BeamDyn – FAST integration

NREL's Test26 with the following changes:

Comparison between initial azimuth angle of 0 and 120 degrees:

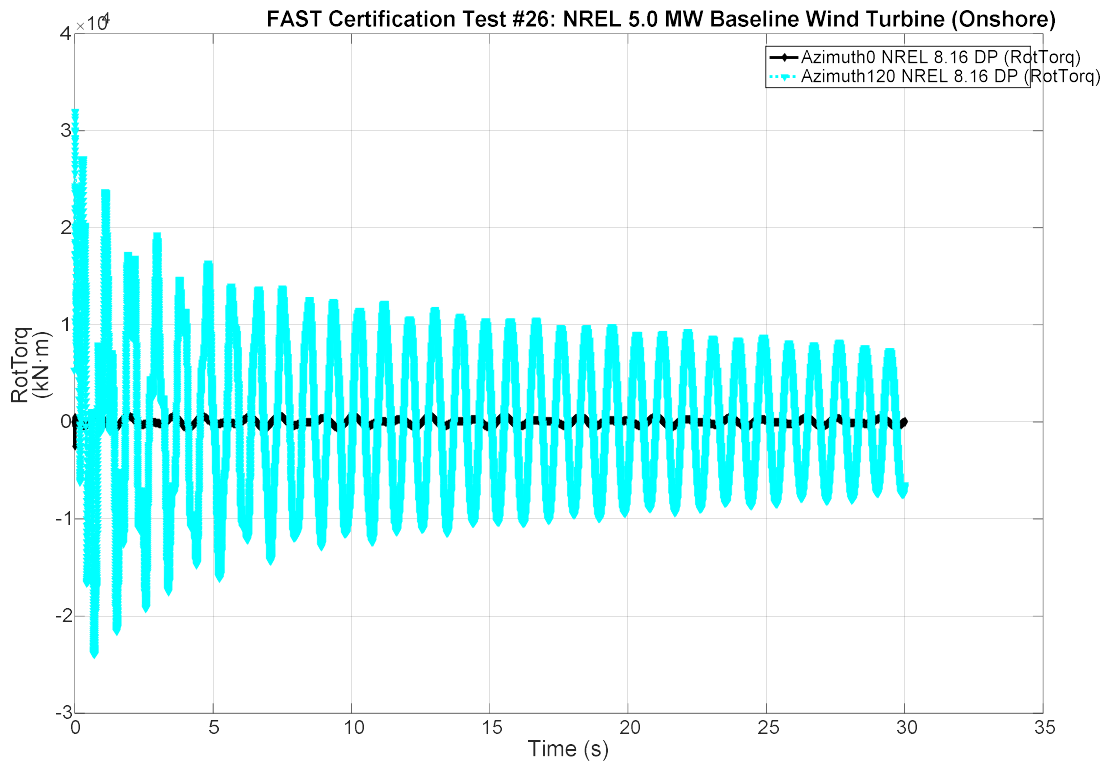
I would expect these two configurations to produce the same overall response, with the blade numbers switched. However, the following plots show that there is definitely something strange in the BeamDyn initialization.

The black lines show results with an initial azimuth of 0 in blade 1; the cyan lines show results from the 120-degree initial blade 1 azimuth. It is interesting that even in the 0-degree initial azimuth case, the RootMxr signals for blades 2 and 3 show higher frequency content than blade 1.
